MEMORANDUM

May 8, 2008

RE: **Arizona Grand Resort – Guadalupe FRS Emergency Spillway Analysis**
Revision of Hydraulic (HEC-RAS) Model and Storage Volume Comparison

FIG 3: HEC-RAS EXHIBIT

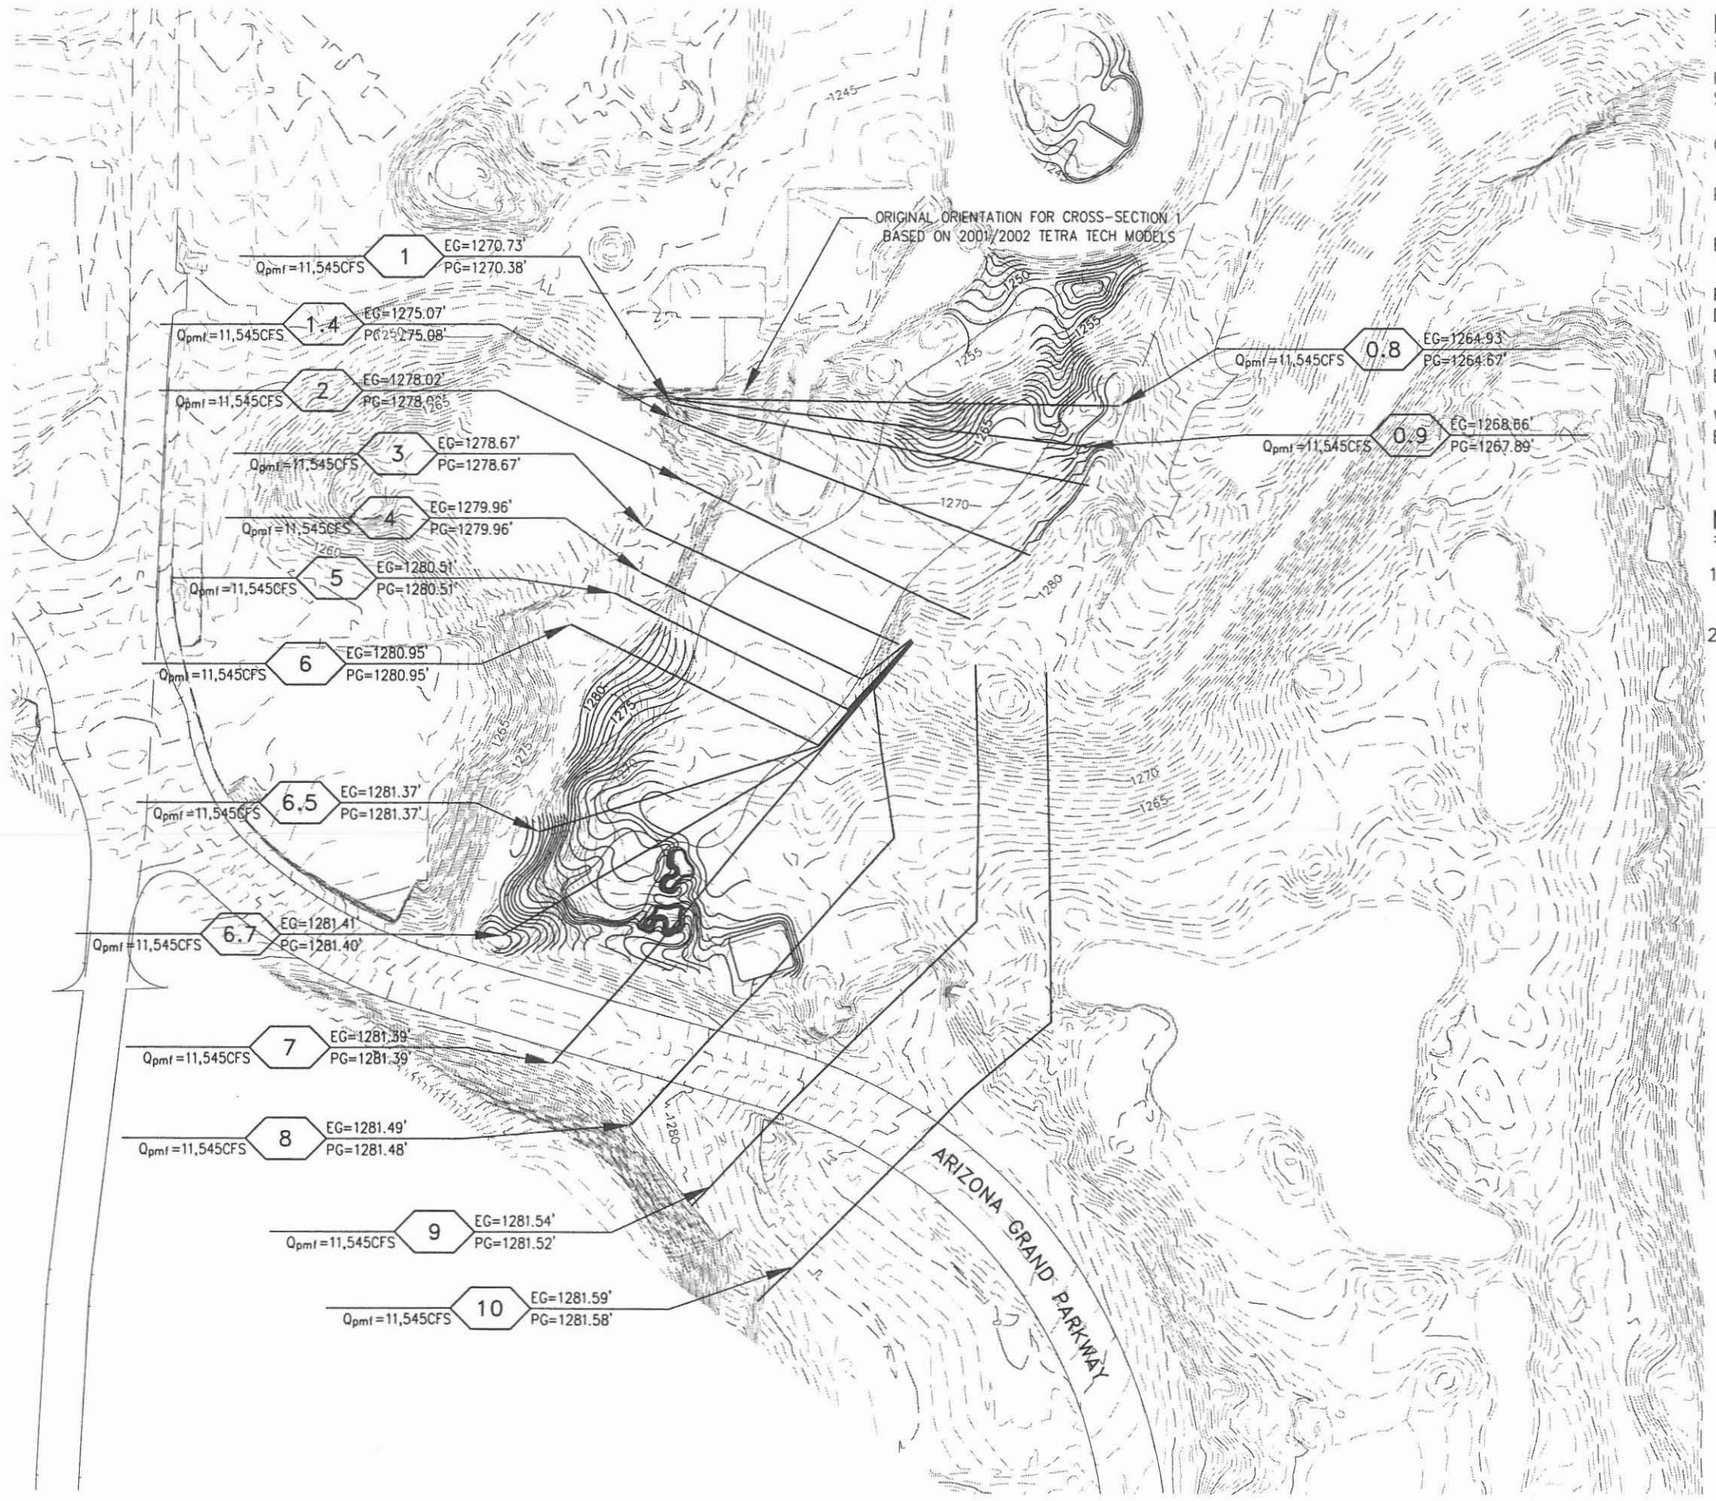
Near the conclusion of the April 15th meeting, it was noted that while the proposed elevation contours for the golf course modifications would result in a net increase to the FRS storage capacity measured to the top of the dam (1281.50 feet), there was a net decrease when assessing the storage capacity up to the emergency spillway crest elevation (1,274 feet).

During the April 15th meeting, Mr. Dan Lawrence (FCDMC) indicated that it would be desirable for CMX to coordinate with the Hydrology and Hydraulics (H&H) Branch of the FCDMC to establish a tolerance between proposed elevation contours submitted in conjunction with the proposed golf course modifications, and the as-built elevations that will be surveyed in the field following construction. During a phone conversation held April 29th between yourself, Amir Motamedi (FCDMC H&H Branch), Michael Weinberg (CMX), and myself, we agreed that a reasonable tolerance of 0.5 feet was appropriate; that if elevation differences between the as-built and

As discussed above, an updated Proposed Conditions HEC-RAS model has been executed by CMX to reflect the revised proposed elevation contours. Two cross-sections not present in the original model have been added downstream of river station (RS) 1. These sections are labeled RS 0.9 and RS 0.8, bringing the total number of cross-sections to fifteen (15). Each of the sections was re-extracted using a digital surface representing the new proposed topography for the study area.

The results of the revised Proposed Conditions HEC-RAS model indicate that the proposed elevation contours associated with the golf hole realignment project will not cause an increase to the water surface elevation or flow velocity of storm water discharge passing over the emergency spillway during the PMF storm event.
